Advanced Reactor Program

CEB92-41

Subject: Clarification / Additional Information Needed for Closure of
Level 2 PRA Issues

Figure COPS-1.1
IMPACT OF COPS ON RISK

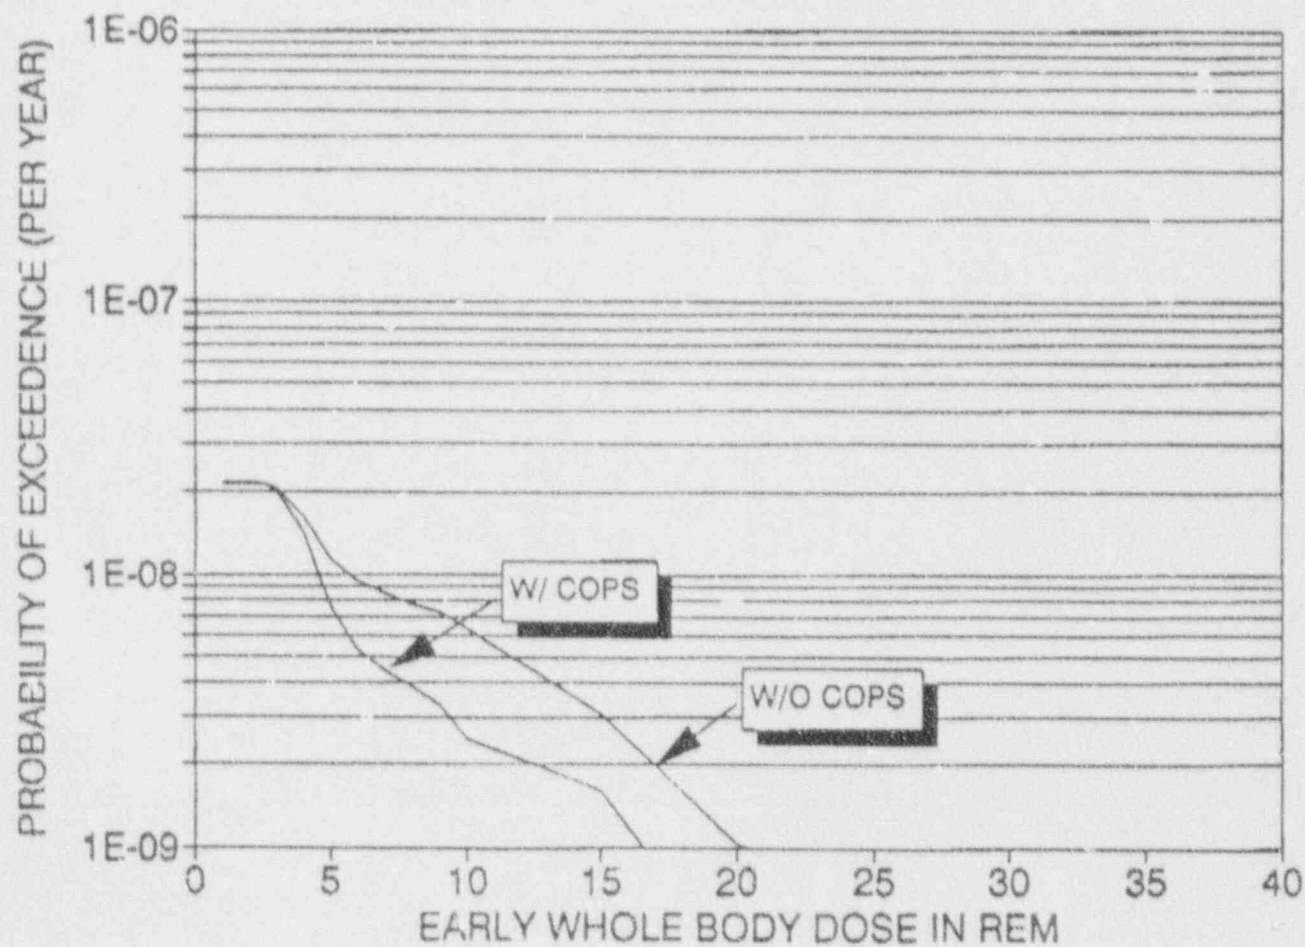
Section X.4.1 provides a comparison of sequences with and without COPS. This assessment is insufficient to fully resolve the issue regarding net risk impact of COPS (O-14). Specifically, the net risk impact of COPS, and the effect of suppression pool bypass, CCI, etc. on this result cannot easily be ascertained by comparing results from MAAP calculations with and without COPS. Rather, the net risk impact should be assessed based on considering the impact of the system on the CET results, i.e., by assessing the risk profile or CET end states with and without COPS. In this way, any effects that system would have on shifting releases from one release category to another, or any interactions between phenomena/events would be accounted for. The information provided in Section X.4.1 of CEB-92-X should be supplemented in this regard to resolve the issue.

The net risk reduction associated with the implementation of the COPS system in the design of the ABWR is summarized in Table COPS-1.1 and Figure COPS-1.1. All sequences which would result in COPS operation were assumed to lead to failure of the drywell head. This may slightly overpredict the probability of drywell head failure since there will be somewhat more time available for the recovery of containment heat removal if the COPS system were not present. Table 6 [of CEB-92-X] indicates a low probability of RHR recovery in the interval between the time of COPS initiation and the time of drywell head failure if COPS were not present. For the case with firewater addition to the containment, the probability of RHR recovery during the period of interest is 4%. Therefore, no significant error is introduced into the calculation.

Table COPS-1.1 indicates that the probability of drywell head failure increases by a factor 50 for sequences with core damage (Classes I and III) if the COPS system is not present. For Class II sequences, the loss of containment heat removal may lead to core damage for those sequences which have drywell head failure. Since the probability of drywell head failure increases by a factor of 100 without the COPS system, the core damage probability associated with Class II events also increases by a factor of 100. Figure COPS-1.1 shows the probability of exceedance versus whole body dose at 1/2 mile for the ABWR and for the ABWR without the COPS system. The offsite dose is reduced as a result of the COPS implementation into the design.
